RESPONSE TO REQUEST FOR ADDITIONAL INFORMATION

APR1400 Design Certification

Docket No. 52-046

RAI No.: 255-8285
SRP Section: 03.08.05 – Foundations
Application Section: 3.8.5
Date of RAI Issue: 10/19/2015

Figure 1 – Analysis Procedure for NI Basemat.

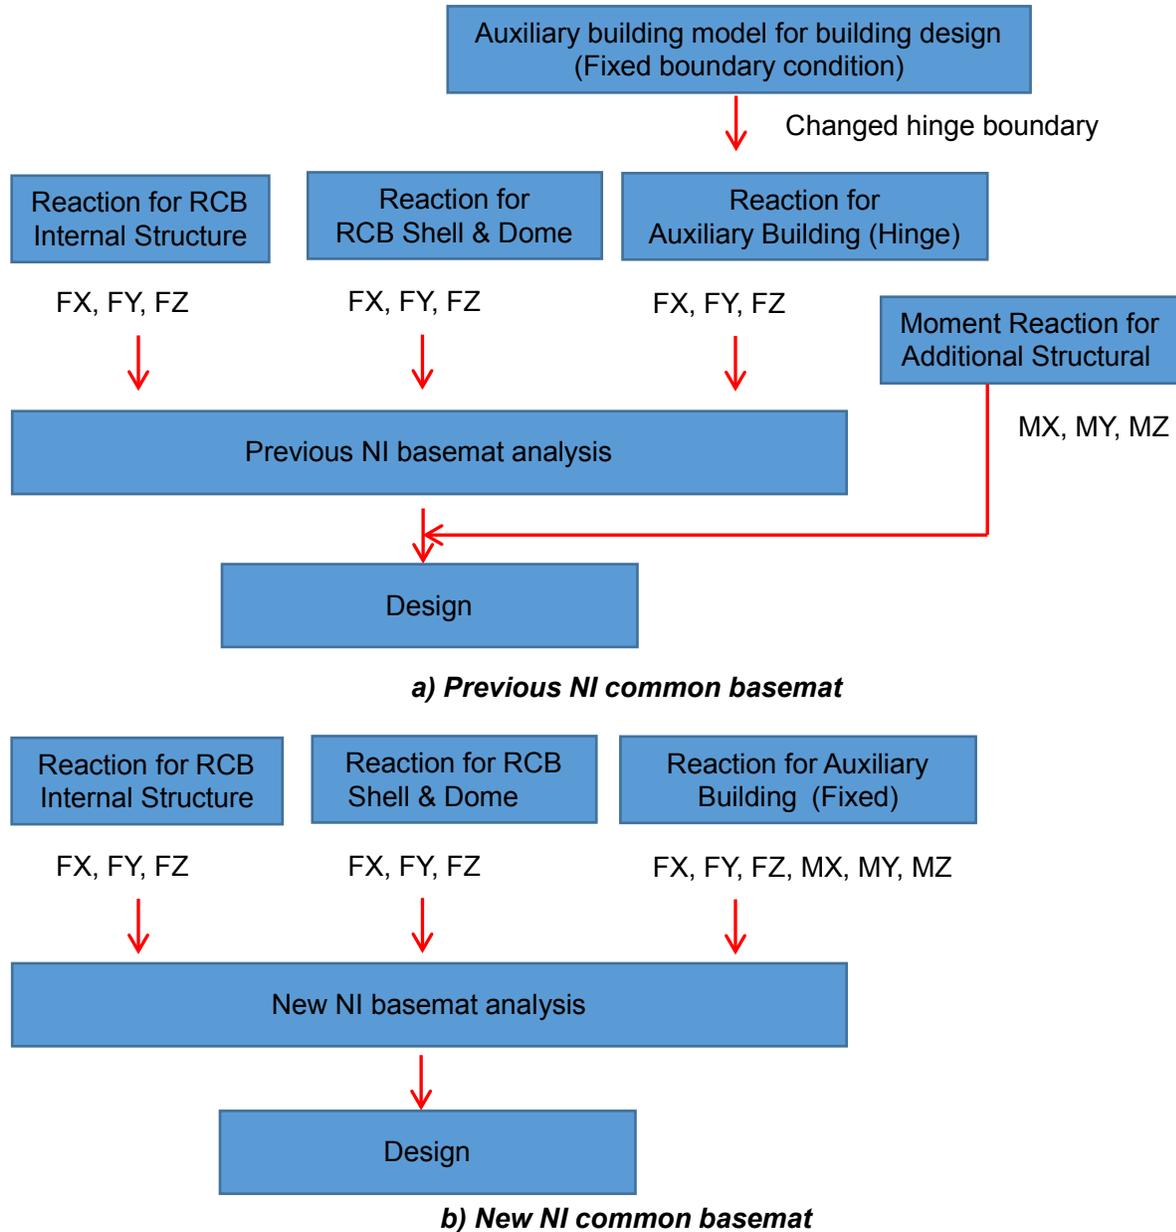
- (c) In DCD Tier 2, Appendix 3.8A, “Structural Design Summary,” subsection 3.8A.2.4.1, “Basemat,” the applicant stated that, “Since the rigid connection between walls and basemat is not simulated in the analysis model of the NI common basemat structure, the basemat of the AB is not subject to any moment that might occur. Therefore, the additional structural analysis was executed to obtain the magnitude of the moment transferred from walls and columns, which were subjected to lateral loads.” The applicant’s approach is not clear to the staff. Therefore, applicant is requested to explain, in sufficient detail, the analysis model, boundary conditions, soil springs, how loads were applied, what accelerations are applied, and why it appears that only additional moments from the walls and columns are applied, and not all forces from the superstructure above the basemat. If only forces from the superstructure were included, then the applicant is requested to explain how the forces from the basemat inertial response were considered in the seismic analysis. The applicant is also requested to explain whether the seismic analysis of the AB basemat was performed separately, or was considered in the same NI concrete basemat model and analysis described in DCD Section 3.8A.1.4.2 used to obtain the member forces.

As shown Table 1, the reaction forces (FX, FY, FZ) from individual RCB Shell &Dome and internal structure analysis were directly applied as input loads at the top of NI common basemat for the NI common basemat analysis. However, for the auxiliary building, the previous NI common basemat analysis used transitional forces and rotational moments, which were calculated separately. In order to minimize confusion in

the structural analysis, the new NI basemat analysis used 3- transitional and rotational moments from the auxiliary building analysis, as shown in Figure 1.

- Explanation of Figure 1 - a)

In order to compute the reaction for auxiliary building analysis, the boundary condition was changed to a hinge support, as shown Figure 1-a). Therefore, only forces from auxiliary building were applied for NI common basemat analysis. The

additional structural analysis was performed to consider out-of-plane moments transferred from superstructure wall to basemat.

In the additional structural analysis, the individual auxiliary building model is used. Applied loads, including seismic acceleration to the superstructure model, are identical to the loads used in the individual auxiliary building structural analysis. For the boundary condition of the additional building analysis, the degree of freedom at the support nodes is only released for rotation to transfer out-of-plane moment to the basemat, soil springs are not considered. This causes out-of-plane moments and forces in the shell elements at basemat. Therefore, both were used in the basemat design. However, the purpose of the additional analysis is to account for the basemat global analysis and capture the local effect on the basemat.
